**Rail Central:**

Phase 2a:

Localised Consultation –  
plans pack for consultation

# Updated draft highways 'red line' plans: the Order Limits A43 / Northampton Road

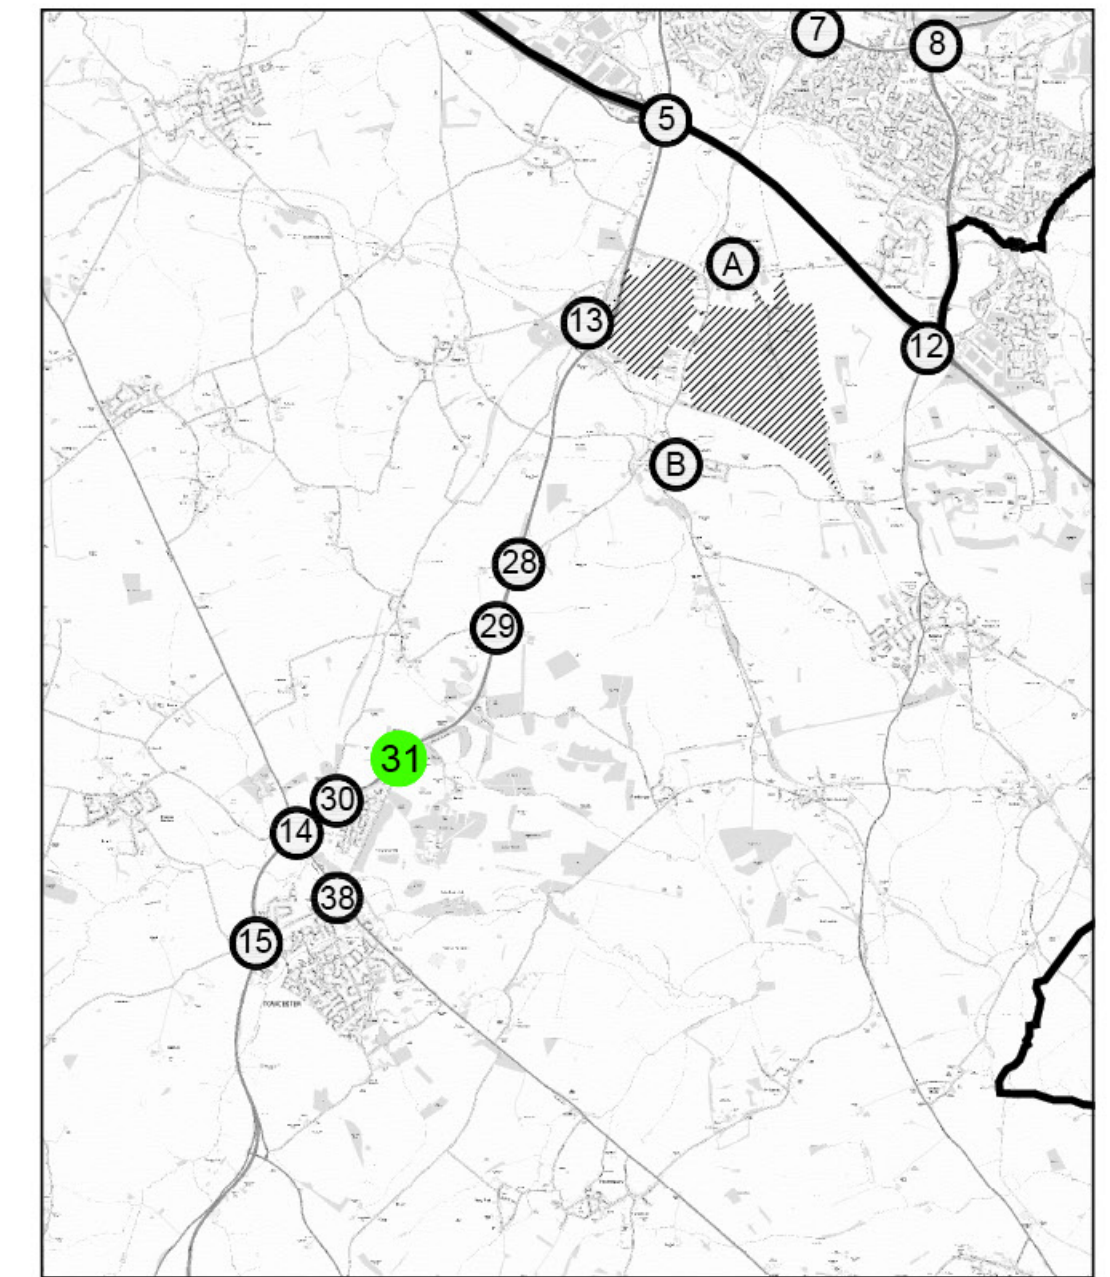
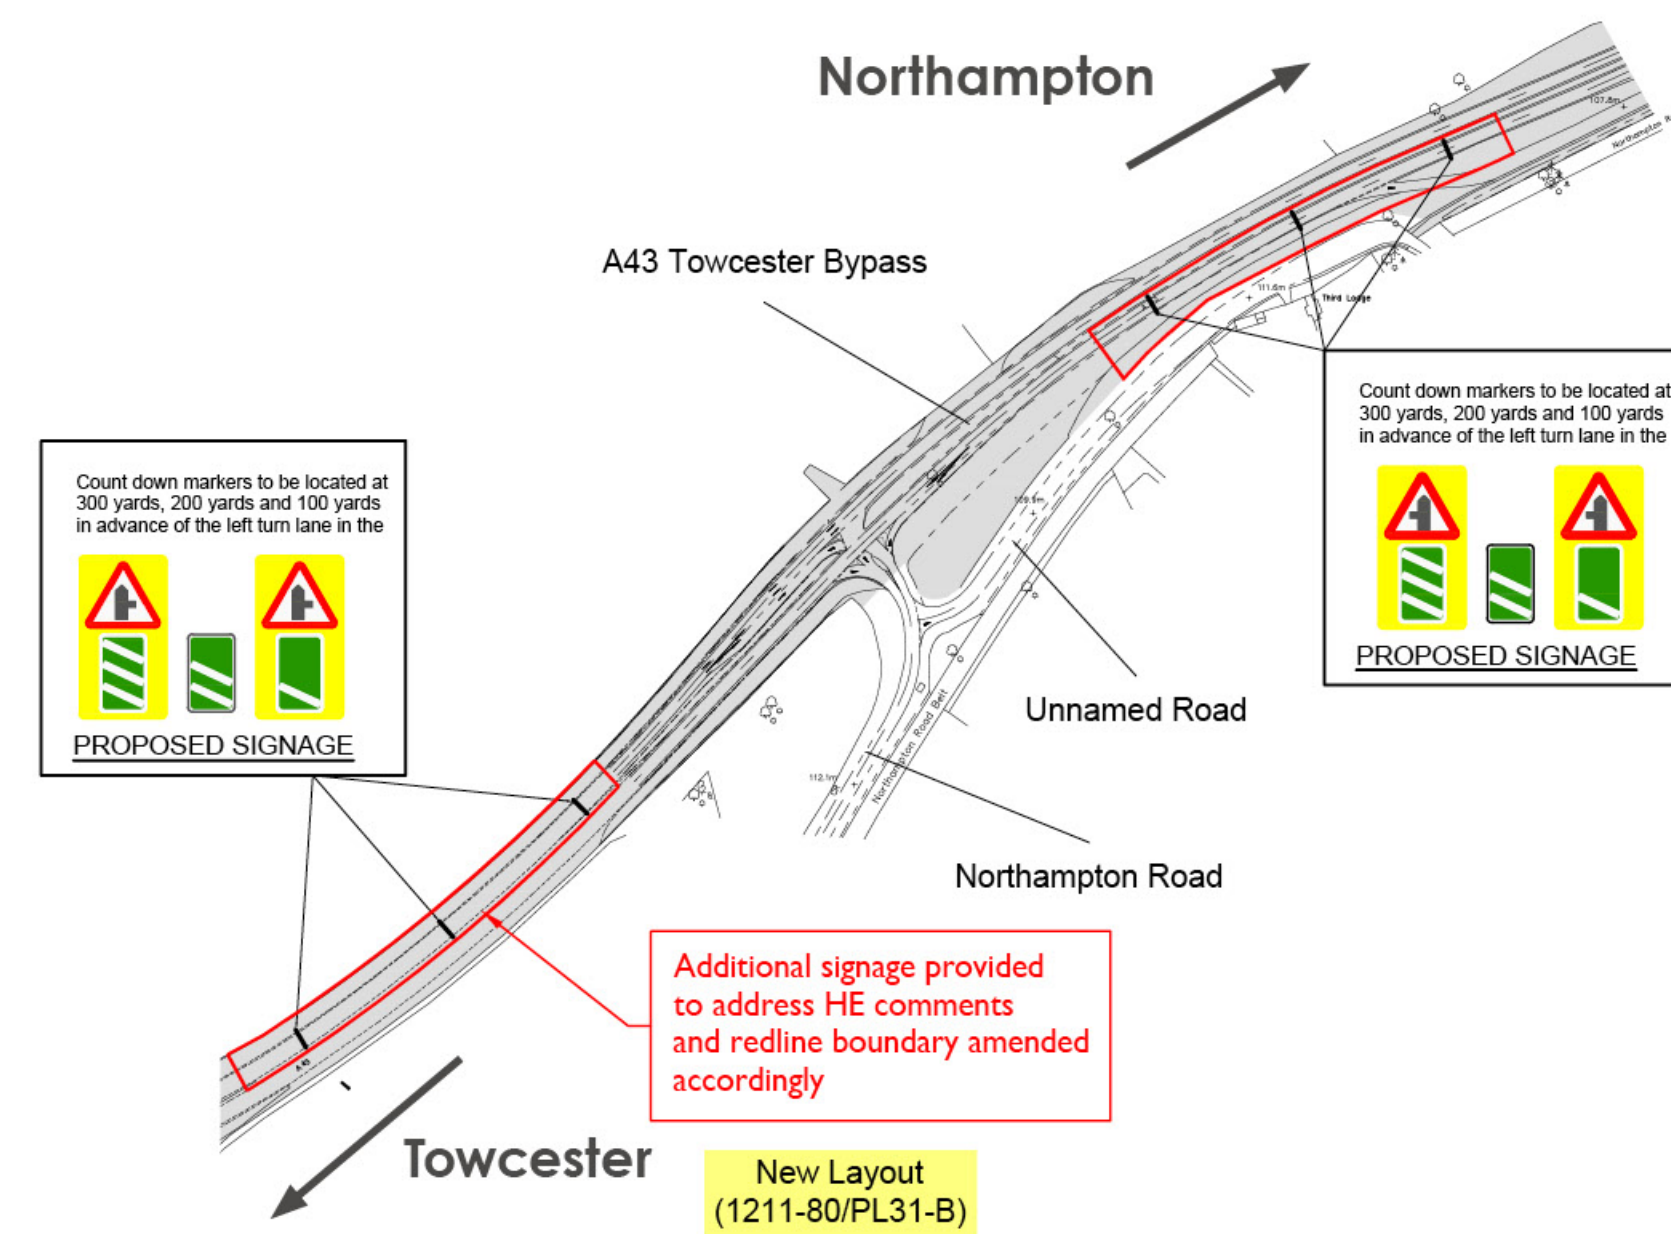
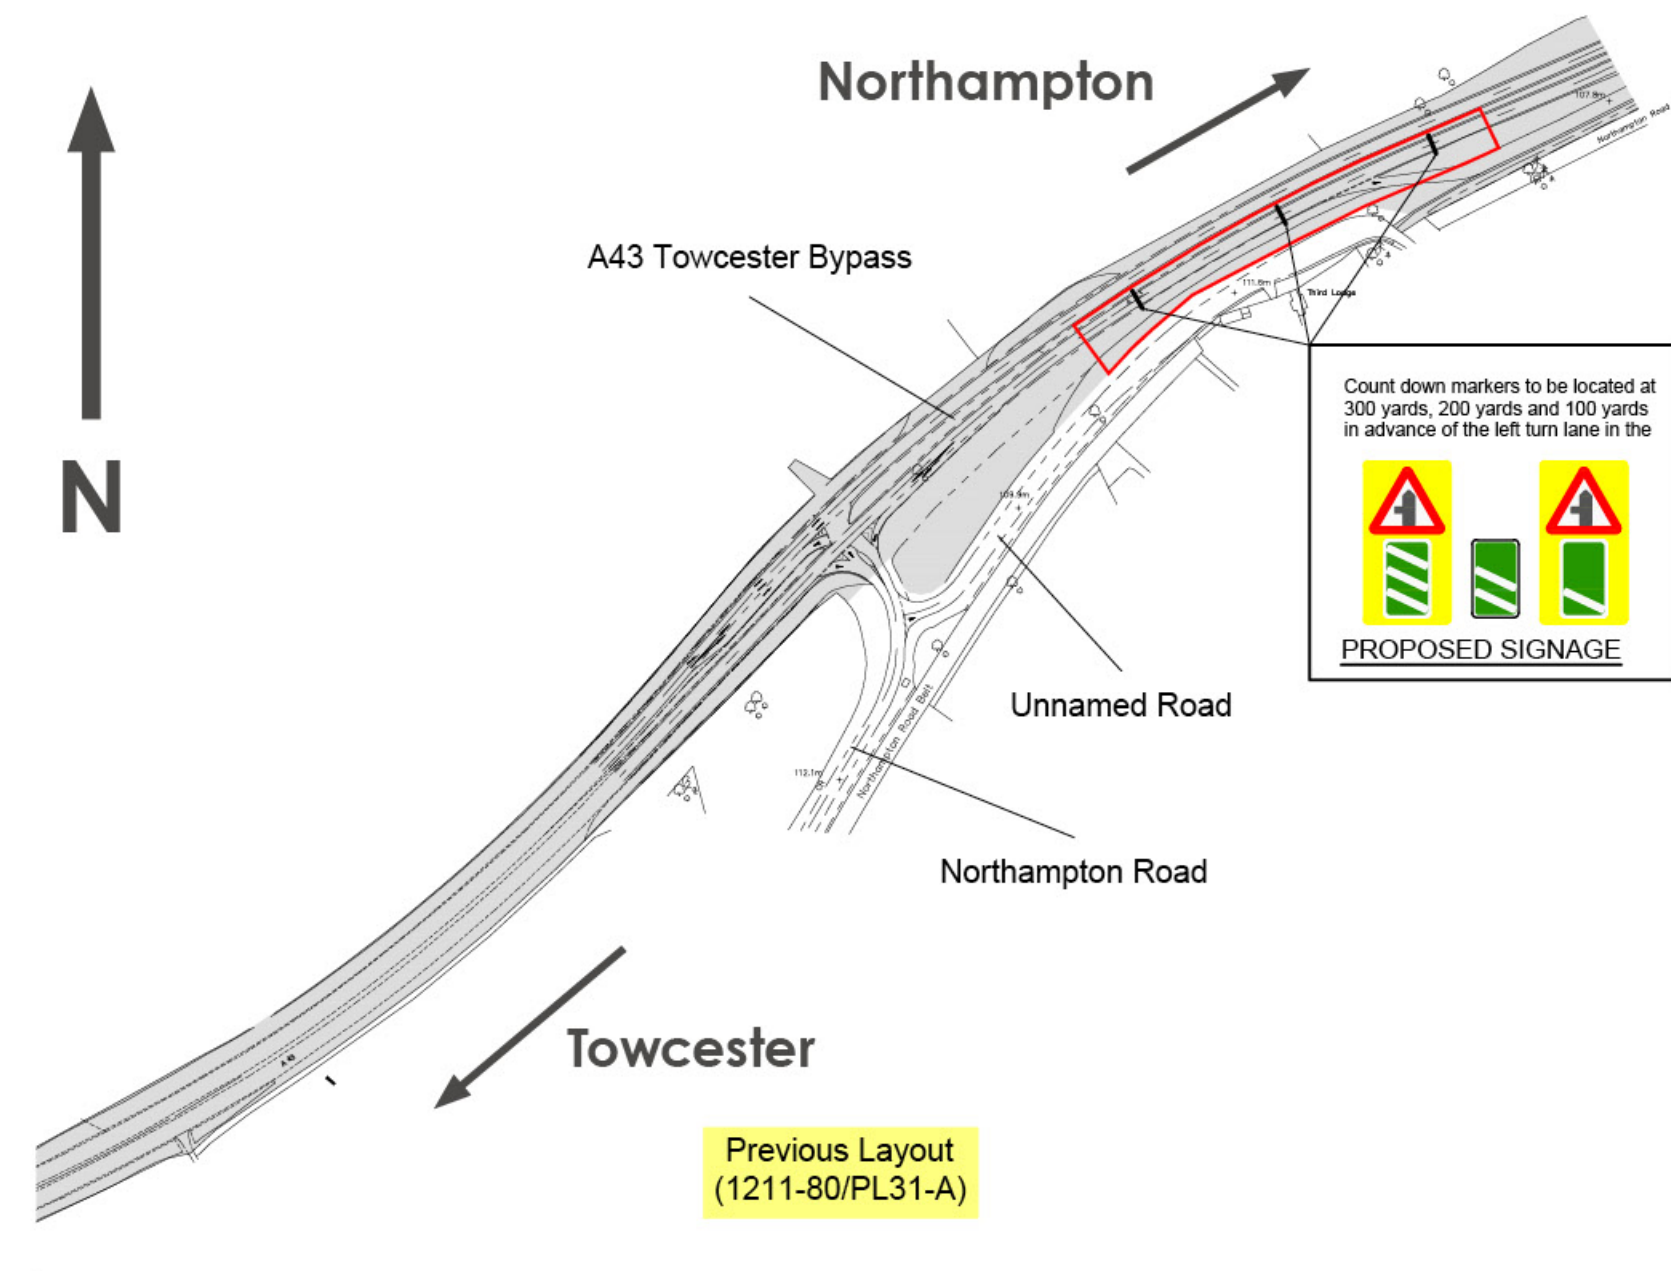
- Minor alterations to the red line boundary (known as the Order Limits) highway junctions:
  - A43 / Northampton Rd (Safety Scheme): this change is simply the introduction of additional safety signage to the south of the junction. It was prompted by Highways England, which requested that proposed signage should be replicated on both directions;
